INDESIT company

Model type:
ALD80EX

Commercial code:
F028066

FIG. 1

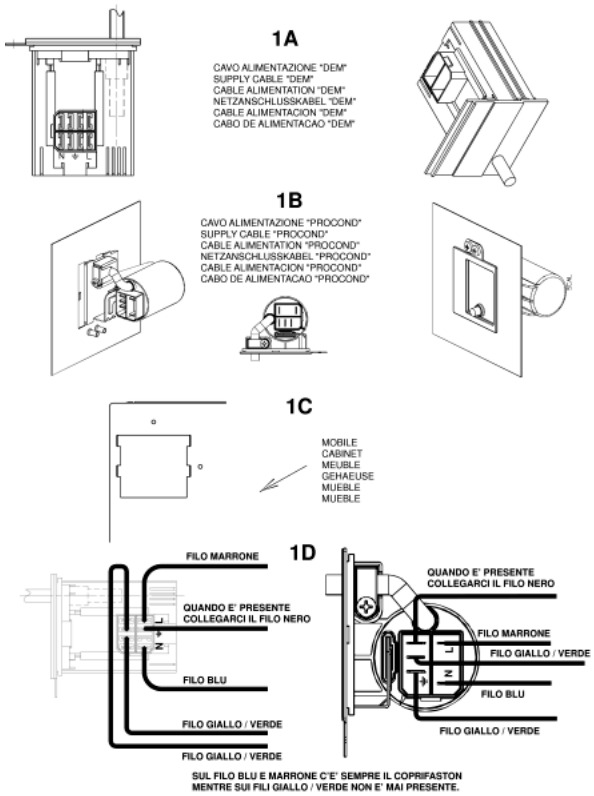
n1040276: Power supply cable + integrally moulded filter.

All appliances produced in the Comunanza (from serial no. 21008.0001), Teverola (from serial no. 21111.0001) and Brembate (from serial no. 21119.0001) factories have been equipped with power supply cables with integrally moulded filter (see fig.1 - 1A and 1B) and new units having a specific opening at the back for fixing the new cables (see fig. 1 - 1C).
The new units, together with the new cables, can be used in place of the premodification ones, by connecting the wiring to the cable, as shown in figure 1 - 1D.
The codes of the new units and of those replaced (ESI - table n1040276fig02), which will be managed until stocks run out, are given below.

IMPORTANT: the fixing / continuity screw is a specific self-scraping screw (code 092348) that ensures earth continuity between the filter and the unit. The same screw must be refitted in order to guarantee machine conformity.

The premodification wirings, are also managed for modified products by making the connection to the terminal block of the new cable as shown in fig. 1 - 1D.
The wiring diagrams given in the Documentation remain unchanged.

The new power supply cables are:
Code 091632 - Power supply cable 3x1 schuko 1.5m+capacitance filter;
Code 091633 - Power supply cable 3x1 schuko 1.5m+inductive filter;
Code 091634 - Power supply cable UK 3x1 l= 1950mm + inductive filter;
Code 091635 - Power supply cable UK 3x1 l=1950mm+capacitance filter;
Code 091636 - Power supply cable l=2.55m AUS+inductive filter;
Code 091641 - Power supply cable l=2550mm AG +capacitance filter;
Code 091642 - Power supply cable 1.85mt SHUKO no inductive filter;
Code 091643 - Power supply cable 3x1 (CH) 1.5m+inductive filter;
Code 091645 - Power supply cable 3450mm SOUTH AF.+capacitance filter;
Code 091690 - Power supply cable shuko l2.55m KOREA+inductive filter;
Code 091689 - Power Supply cable l=2550mm AG+inductive filter.

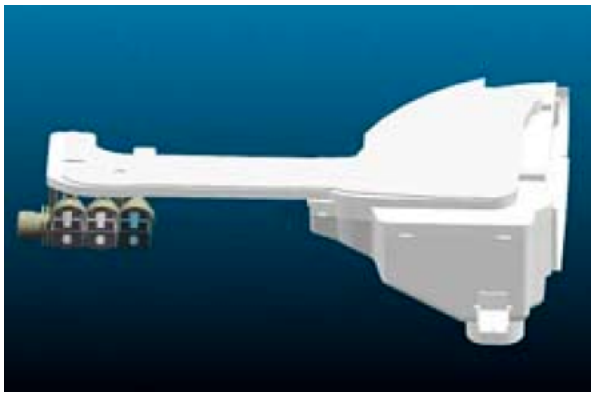
n1040282: New drainage OKO system.

From serial number 21219.0001, the new "OKO" drainage system has been introduced on the washing machines produced in the Comunanza factory.
The last two numbers of the Industrial Code (located on the rating plate) of the models relevant to this note will be 30 (e.g. 80233560130 - see Appendix A)

- EEPROM (the OKO system requires a new setting of load timing parameters). THE NEW EEPROMS REPLACE ALL THE ONES CODED PREVIOUSLY.
- BOWL (hopper tube hole shifted forwards);
- DETERGENT LOADING TUBE (see fig. 1);
- PRESSURE SWITCH (changed levels);
- OKO PUMP BOWL BLOWER + BALL (see fig. 2A, 2B and 2C);
- CONDUCTIVITY SENSOR (if provided, it is shorter than the premodification item);
- DRAIN PUMP (without detergent collecting tube connection);
- HOPPER (shifted in front of detergent loading tube connection). Fig. 3A post-modification. Fig. 3B premodification);
- AIR TRAP (different shape);
- PRESSURE SWITCH TUBE (different length);
- DRAIN TUBE STOP (specific);

In particular, the OKO system consists of a spherical plastic component inserted in the tube that connects the bowl to the drain pump (see fig.2 A).
At the beginning of each wash cycle the washing machine fills water for 10 seconds and activates the drain pump for 2 seconds. In this way, the water level in the bowl is different from that in the drain tube; this difference increases the thrust of the ball upwards, closing the bowl-pump connection tube hermetically (see fig. 2D).
This system has the double advantage of:

1) separating the wash water and the water in the drain hose, thus saving energy during the heating phase;
2) and ensuring optimal use of all the detergent.
With the introduction of this new component, the detergent collecting tube is no longer required and the pump has one hole only to convey water from the tank.
For the correct operation of the OKO system, it is important that the drain hose of the washing machine remains fixed to the back of the unit with a plastic clamp (to this end, the clamp withstands a 25 kg load; see reference 1 in fig. 4); otherwise, the drain hose must absolutely reach the height of the clamp. (minimum 60 cm.)

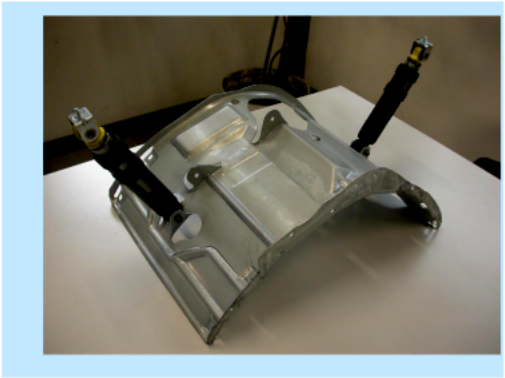
n1040325: New shock absorber fixing system with pin

From serial no. 40427.0001, shock absorbers have been fixed to the tank unit cradle with two 11 mm pins code C00110163 (see fig. 01 and 02 enclosed) in place of the 8 mm screws code 093750 and relevant locking nuts code 030443, on all washing machines and dryers produced in the Comunanza factory.
The items affected by this modification are:

2) The new shock absorbers, with fixing bushing having no s/steel spacer, are not managed as they are interchangeable with the premodified items (make sure they are CIMA type, as the managed items), fixed with M8 screws code 093750 and related locking nut code 030443 (see figs. 05 and 06).
Code 093884 - Shock absorber 80 N
Code 093885 - Shock absorber 100 N

To remove the shock absorber from the tank, first extract the pin with a few hammer taps (see fig.03) until it is aligned with the tank bracket and then pull it out with a pair of pliers (see fig. 04).
(To refit the shock absorber use a new pin. Insert the pin until the toroidal edge is aligned with the bracket.)

1) The cradles have the same Service code, as they can be used in place of the new ones after widening the shock absorber fixing holes to a diameter of 10 mm.
Code 093848 - Tank unit cradle 46 lt
Code 093878 - Tank unit cradle 40 lt.

Fig . 001

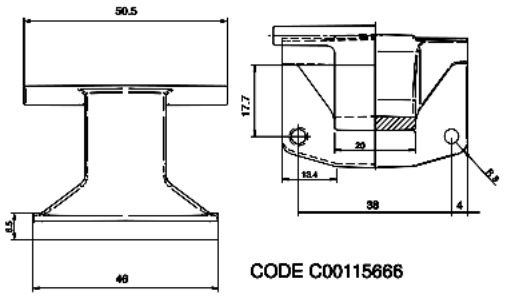
n1040349: Introduction of 150° Zamac hinge on Ariston 46 models.

From serial no. 50207.0001, all Ariston models produced in the Teverola factory (see table 001 attached) with industrial code (given on the rating plate) starting with 46, have been equipped with a Zamac hinge with 150° opening angle, code C00115666

(see Fig.001).
This modification has involved the introduction of the following items:

Code C00115670 - Complete door EVOII 150° white 27 with standard glass;
Code C00115674 - Complete door EVOII 150° white 27 with long glass;
Code C00115667 - EVOII body for 150° hinge white 27;
